# MANDATORY service bulletin

M87-24  
Supersedes M87-13

**SUBJECT: BROKEN STARTER ADAPTER SHAFTS**

**AFFECTED:** IO520BA, IO520BB, IO550B, TSIO520BE, TSIO520LB, TSIO520UB & TSIO520WB

**FIGURE A**  
**CASTELLATED**  
**P/N MS9358-15**

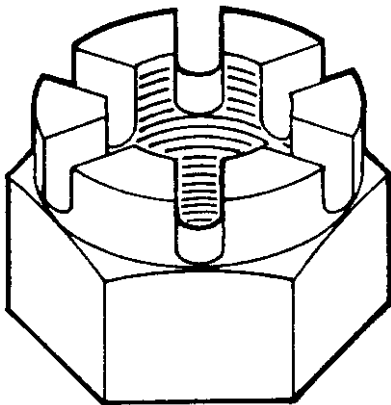
2. If the castellated nut is not the original but a substitution for the originally installed steel locking type nut, remove the freon compressor drive belt. This can most easily be accomplished by cutting the belt.

**FIGURE B**  
**STEEL LOCKING**  
**P/N 649311**

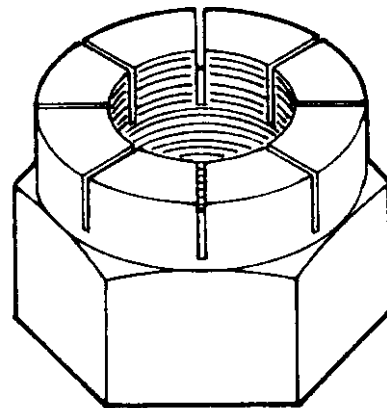
- I. Gain access to the drive sheave mounted on the rear of the starter shaft. This sheave is concave and approximately 3.375 inch in diameter (3-3/8 inch).
- II. With a light and mirror, determine if the sheave is a steel locking type. (See Figure B.)
  - A. If the nut is a steel locking type (See Figure B), remove the freon compressor drive belt. This can most easily be accomplished by cutting the belt.
  - B. If the nut is castellated (See Figure A), ascertain via log books and maintenance records that the castellated nut is the original nut and has not been substituted for a steel locking type nut.
    1. If the castellated nut is the original, no further action is required. Make the appropriate log book entry stating compliance with this service bulletin and return the engine to service.

NOTE...REMOVAL/CUTTING OF THE BELT IS REQUIRED IF THE STEEL LOCKING TYPE NUT IS INSTALLED OR HAS PREVIOUSLY BEEN INSTALLED REGARDLESS OF THE SHAFT TYPE (COTTER KEY HOLE OR NO COTTER KEY HOLE).
